Service Information Bulletins

1997

GRUNDIG
made for you

Colour television receivers with Digi Basic chassis, e.g. ST 70-255 IDTV/LOG, M 70-280 IDTV/LOG, SE 7089 IDTV/LOG

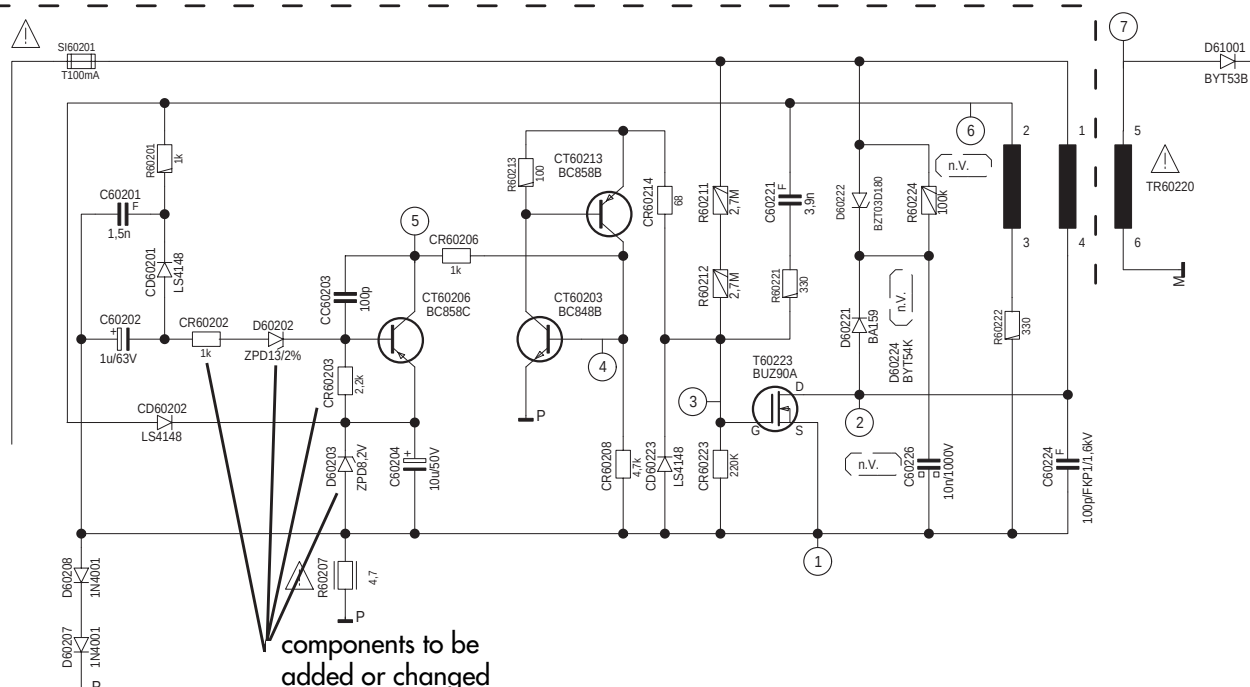
Brown colouration of the circuit board near the diode D 60222 BZT 03D180. Simultaneously the "+Eco" voltage is approx. 5V too high.

Coincidence of unfavourable component tolerances.

Carry out the following changes in the stand-by mains stage:

- Change the Z-diode D 60203 from ZPD 9.1V to 8.2V.
- Change R 60202 from 68 k Ω to 1 k Ω .
- Connect an additional Z-diode ZPD 13 in series with R 60202. Connect the cathode of the diode to the base of the transistor CT 60206.
- Check the rating of the resistor CR 60203 to be 2.2 k Ω .

Portable mono TV/VCR combination TVR 3701 SV

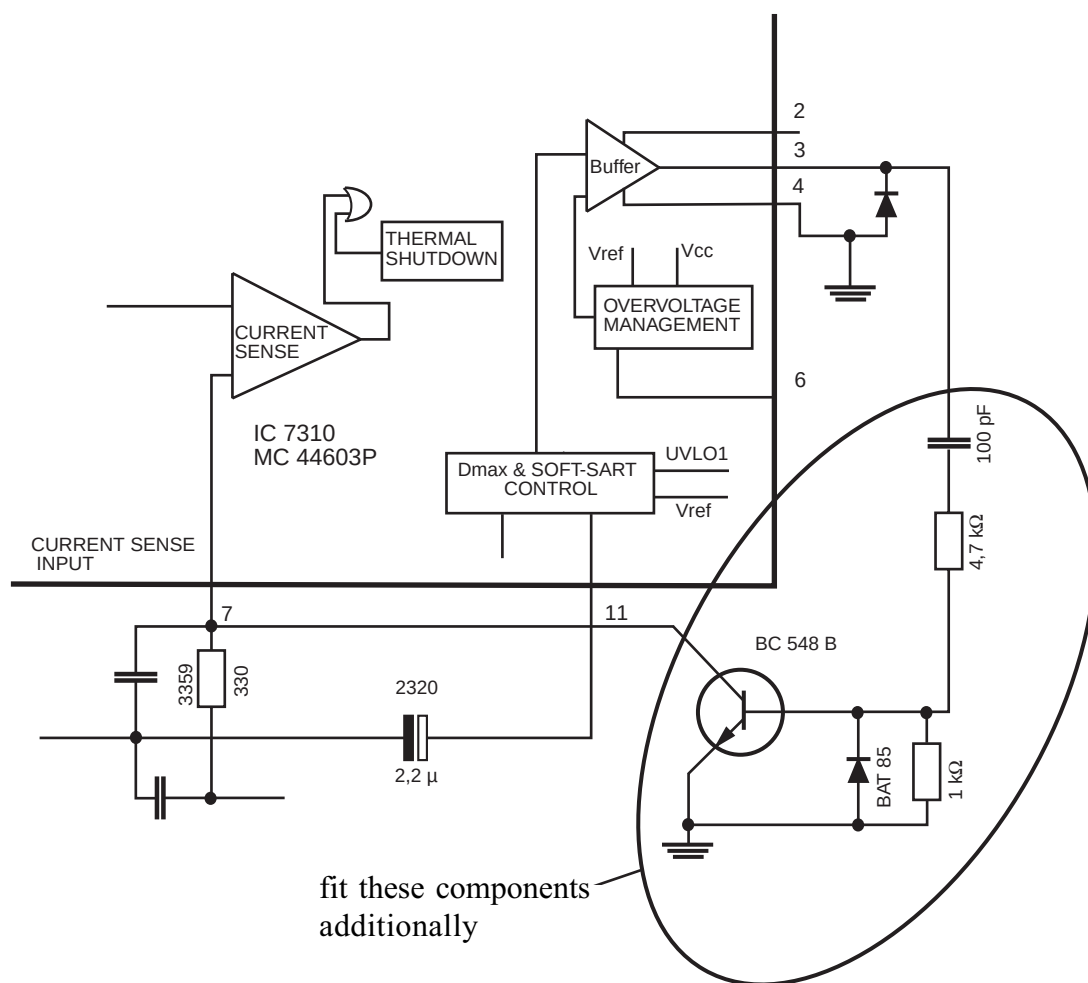
Mains voltage dependent chirp audible in stand-by mode.

Fit an additional transistor stage as shown below into the power supply unit at IC 7310 (MC 44603 P).

37 cm colour television receivers with chassis CUC 7301 text e.g.: P 37-730 text

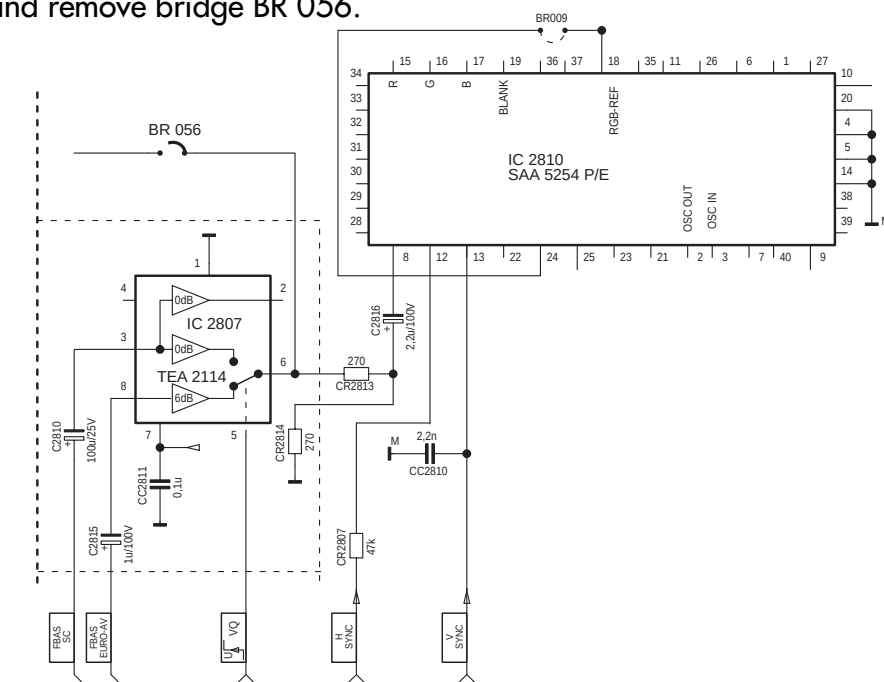
Teletext operation is not possible in "AV" programme position.

The video switch-IC 2807 (TEA 2114) is not fitted in 37 cm television receivers.

Retrofit the following components:

IC 2807 TEA 2114

C 2815 1 μ F

C 2810 100 μ F

C 2811 0.1 μ F

CR 2813 270 Ω

CR 2814 270 Ω

In addition, change the polarity of 2.2 μ F electrolytic capacitor C 2816 (negative terminal to pin 8 of IC 2810) and remove bridge BR 056.

Product **Colour television receivers with chassis CUC 7350, e.g. ST 55-750 text**

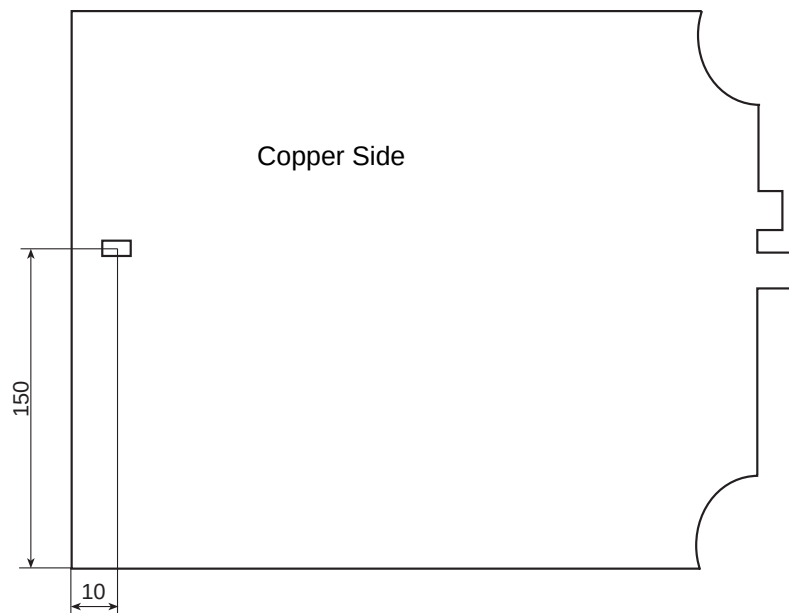
Despite the modifications carried out according to our TV Service Information 9/96 the television sets switch occasionally to Standby after a prolonged time of operation.

Temperature drift of the +E operating voltage by about 0.2 to 0.3V caused by Z-diode CD 61023. Consequently, IC 34015 TDA 8374 switches off with sudden black/white changes in the picture content or changing scenes.

The position of the Z-diode is X=10, Y=150. Unsolder this diode and insert a SMD resistor 1206 1.2Ω 1% in this place.

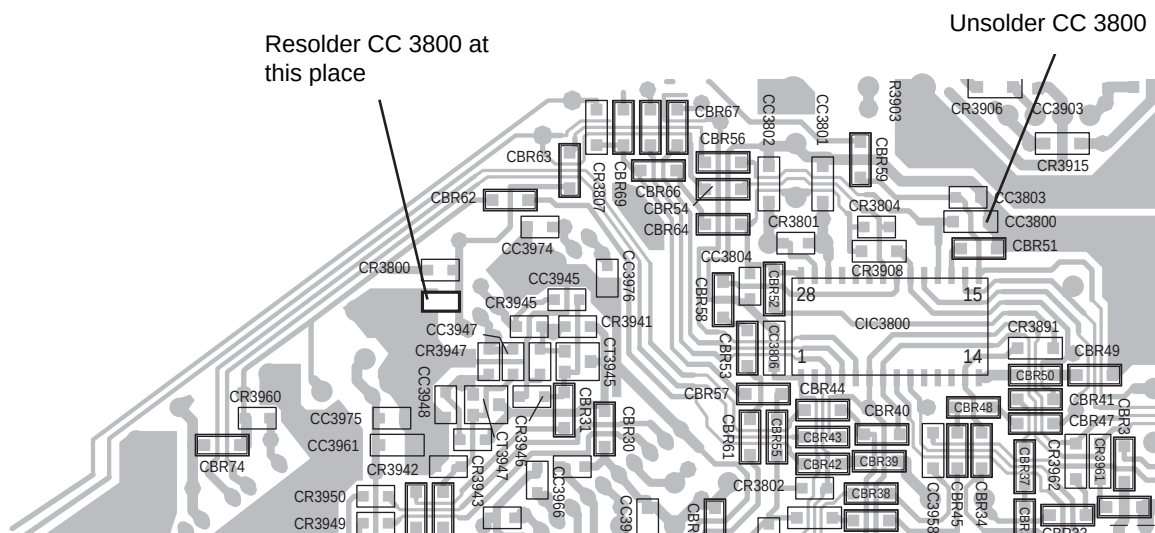
The sound disappears suddenly during the reception of a satellite programme and is audible again only when changing the programme or switching the TV off and on again.

IC MSP 3400 on the SAT Module hangs up by static charges entering the Reset input of the IC.

Unsolder the SMD capacitor CC 3800 from its place on the SAT Module and resolder it at the place indicated on the figure below.

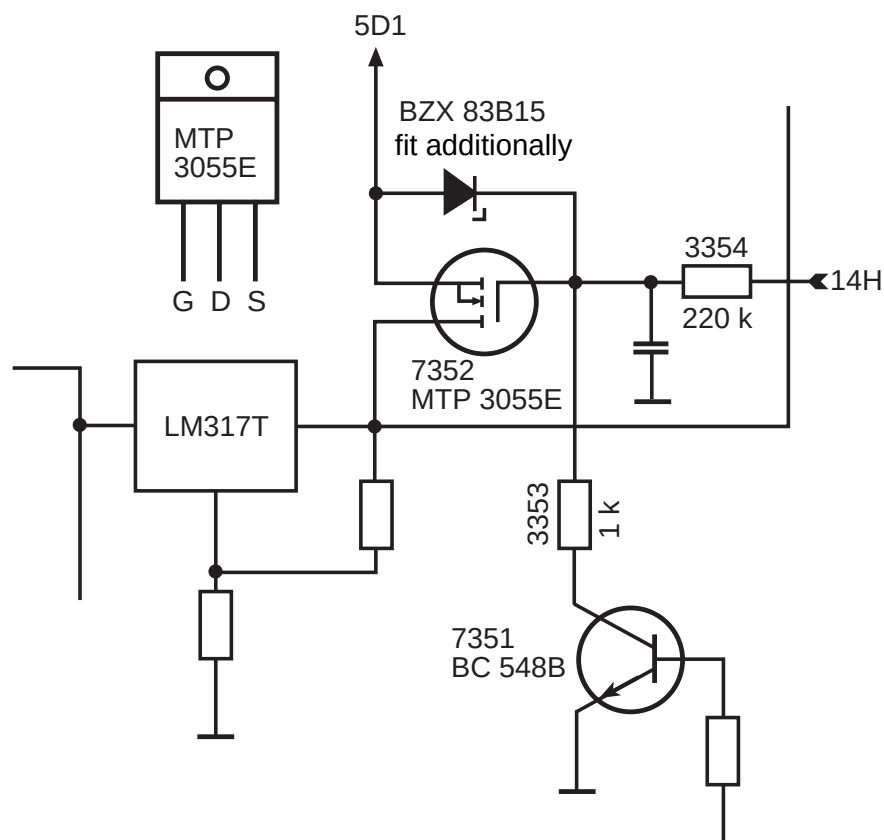
TV Recorder does not operate.

Defect in transistor 7352 (MTP 3055E) caused by static discharges in the TV Recorder.

Fit an additional Z-diode BZX 83B15 between gate and source to suppress voltage peaks at the gate.

The Z-diode must strictly be retrofitted if the transistor 7352 fails. This change is carried out already in the factory.

Product **Colour television receivers with chassis CUC 7303/7305/7350 and the picture tube panels 29305-022.16/-022.17, e.g. P 37-731 text, P 45-731 text, T 55-731 text, P 37-731/12 text, ST 55-750 text, XS 55/1, Lissabon SE 5576 text**

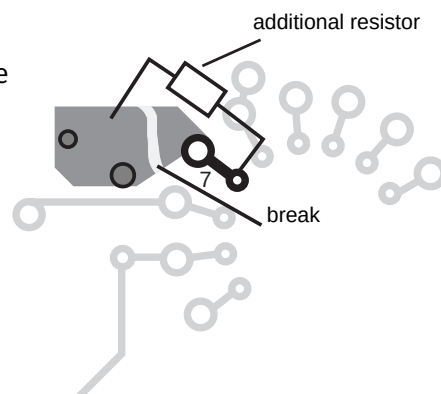
Failure of the RGB output stages (picture tube panels 29305-022.16 and -022.17) or of the teletext function.

The semiconductors are destroyed by high-voltage sparks within the picture tube.

On the picture tube panels -022.16/-022.17, insert an additional 1.5 k Ω composite carbon resistor (do not use a carbon film resistor!) into the circuit path to the screen grid connection of the picture tube socket. Ensure that the break is 2mm wide at least (see figure) to avoid sparking.

Product **Colour television receivers with Digi 6 chassis CUC 1842, 1894, 1952, 1962 and 1983, e.g. M 72-410 Ref., Denver SE 8216/9 PAL Plus, M 70-269/9 Ref.**

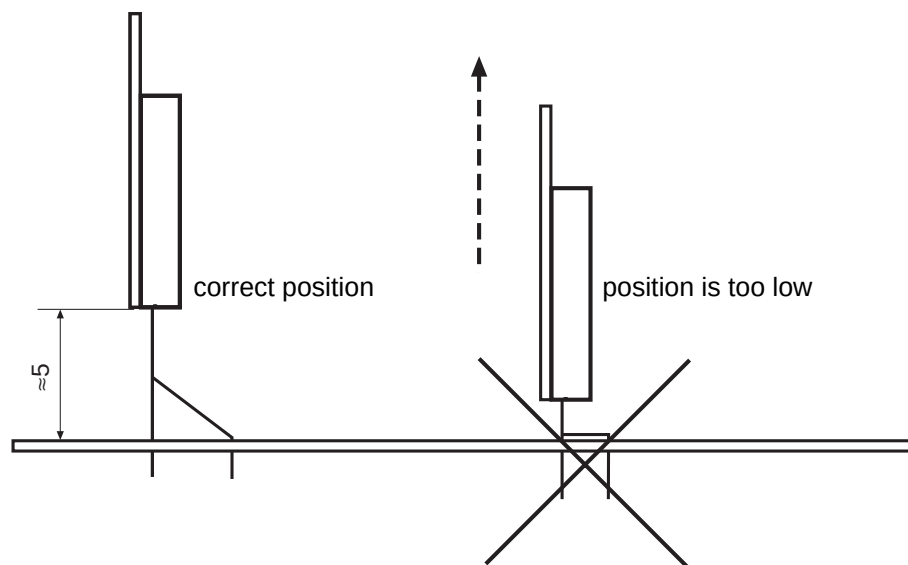
Vertical output stage TDA 4173 fails or thin white lines similar to retrace stripes are visible.

Inherent instability of the vertical output stage IC TDA 4173 AF.

- Should above mentioned symptoms appear do not fail to exchange TDA 4173 AF and solder additionally a 1 nF foil capacitor from pin 1 and from pin 7 each to pin 4 (-K voltage) on the copper side.
- Check the mounting position of the vertical output-IC. If the position of the IC is too low, the pins may temporarily come into contact with the chassis connection on the upper side causing the IC to fail. Additionally, the circuit may already be damaged by the building up force of pressure resulting in a long-term failure. Therefore replace TDA 4173 AF also if it has not been fitted correctly!

Product Colour television receivers with Digi Basic chassis - CUC 1806, 1825, 1826, 1827, 1829, 1830 with the picture tube panels 29305-122.04/-122.10/-122.12 and -122.17
e.g. ST 70-255 IDTV/LOG, ST 72-261 IDTV/LOG, Atlanta SE 7220 IDTV/LOG, ST 72-261 IDTV/LOG

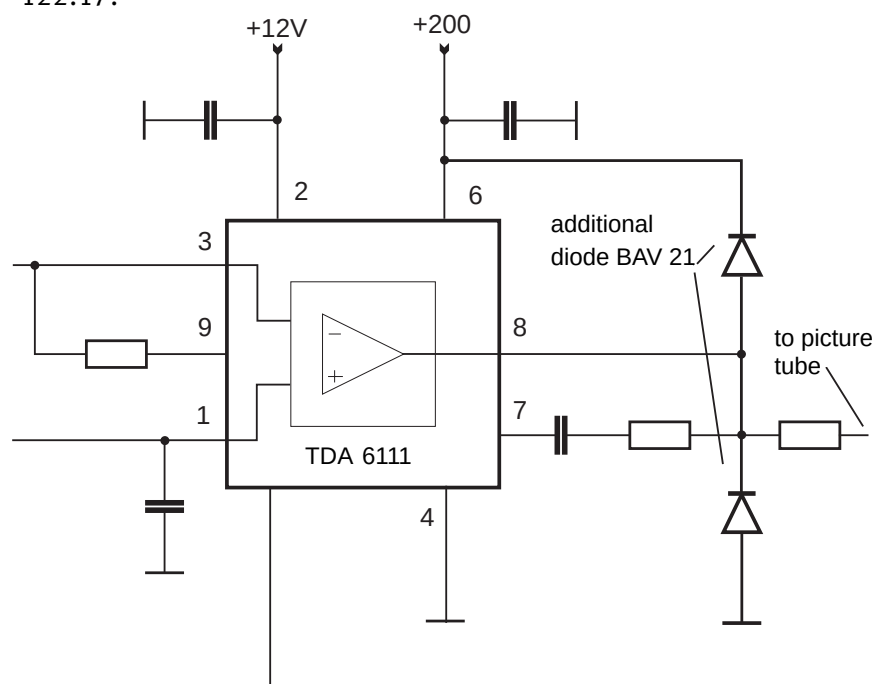
Failure of the RGB output IC's TDA 6111.

The RGB output IC's are destroyed by high voltage sparks.

Directly from the outputs (pin 8) of the three output IC's TDA 6111 connect one additional diode BAV 21 each to chassis and one diode each to the +200 voltage (see figure).

The insertion of the three diodes which are to be connected to +200 is already prepared on the picture tube panel by the diodes D 734, D 754 and D 774.

The three diodes which are to be connected to chassis are to be soldered on to the copper side from pin 8 to pin 4 (anode to pin 4).

Product **Series GV 4xx video recorders with „World Deck“**

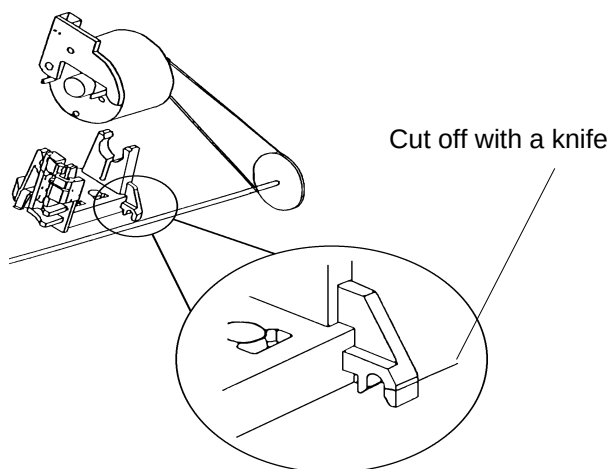
Drive mechanism does not move.

Slipping of the bevel gear of the pulley shaft (pos. 47) and / or worm shaft (pos. 48).

Replace the pulley shaft and / or worm shaft.

To replace the pulley shaft quickly follow the instructions given below:
Dismantle the drive mechanism, set the drive mechanism to EJECT position, remove the cassette compartment, remove the threading belt, detach the worm shaft and the pulley shaft,

cut the motor holder with a knife as shown on the figure below,
pull out the pulley shaft, fit and snap in the new pulley shaft and worm shaft, refit the cassette compartment as described in the Service Manual.

Product **GV 660 / GV 690**

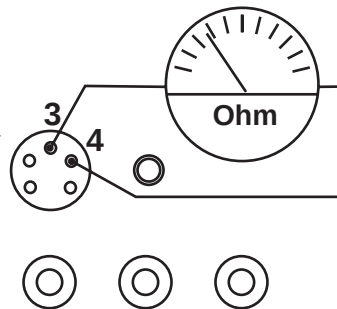
Master/Slave and Synchro Edit control functions do not work.

In a small number of GV 660 and GV 690 video recorders, the 7-pin cable (pos. 9511) from the keyboard control unit to the teletext module is not inserted correctly (laterally inverted) on the keyboard control unit.

Disconnect the 7-pin cable from connector 1511 on the teletext module, turn it by 180 degrees and refit it.

Chassis Board - Head Amplifier

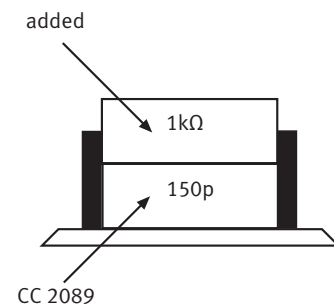
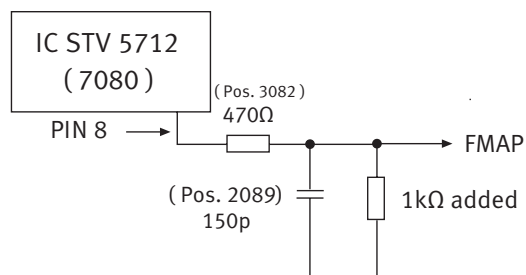
Disturbances and noise along with the HIFI sound.

No steady audio-FM signal identified on playing back.

Carry out the following changes on the chassis board - head amplifier.

1. Change CR 3082 from 100Ω to 470Ω.
2. Change CC 2089 from 220p to 150p.
3. Add CR 1kΩ to CC2089.
